PLANNING CLEARANCE
(Single Family Residential and Accessory Structures)
Grand Junction Community Development Department

BLDG ADDRESS 709 FOUNTAINHEAD BLVD TAX SCHEDULE NO. 2701-334-14-016

SUBDIVISION THE COVE AT FOUNTAINHEAD SQ. FT. OF PROPOSED BLDG(S)/ADDITION 40x40

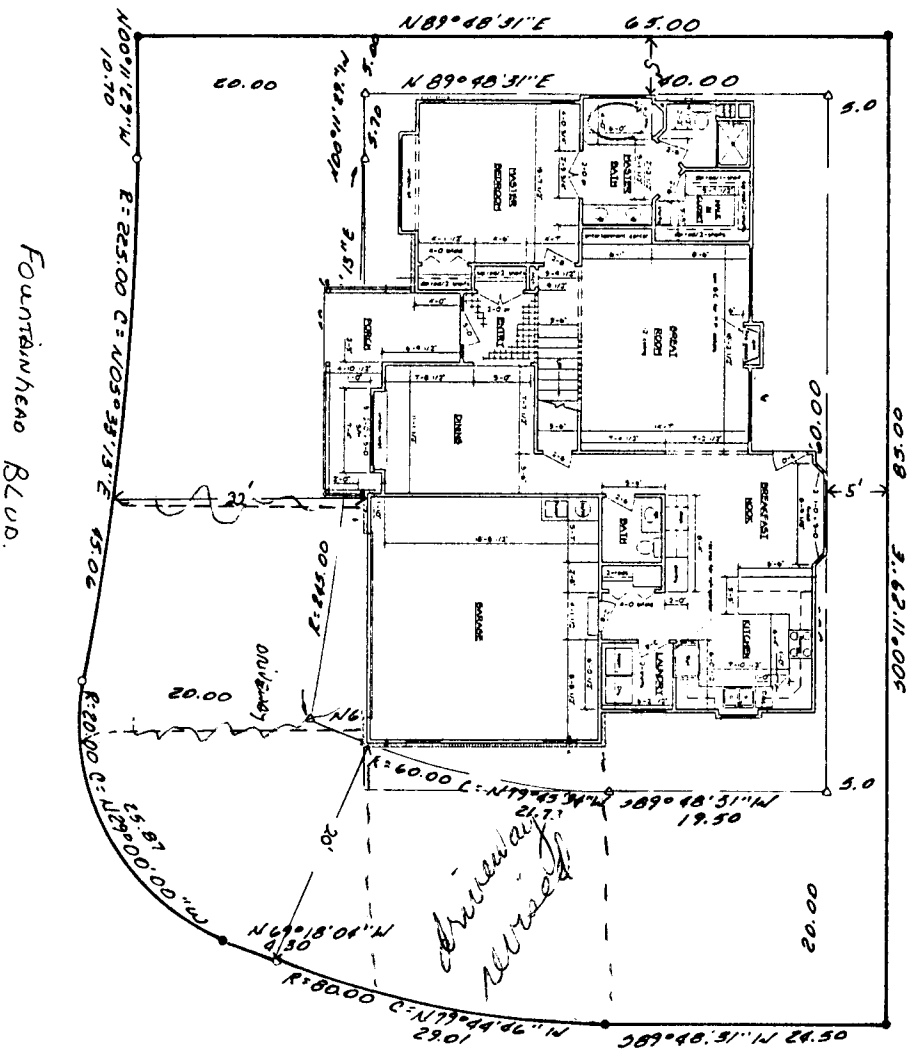
Revised
Ronnie 3/20/96

Driveway
Location Revised

ENTER REVERSE
 DRIVEWAY LOCATION
 OR FOUNTAINHEAD
 BLVD. OR LOCATE
 ON E. Harbor
 Circle, Drive
 IS TOO CLOSE TO
 INTERSECTION,
J. Clark
 2-20-96

DRIVEWAY
LOCATION OK
 Jody Khila
 2-21-96

ACCEPTED *Ronnie* 3/26/96
 ANY CHANGE OF SETBACKS MUST BE APPROVED BY THE CITY PLANNING DEPT. IT IS THE APPLICANT'S RESPONSIBILITY TO PROPERLY LOCATE AND IDENTIFY EASEMENTS AND PROPERTY LINES.
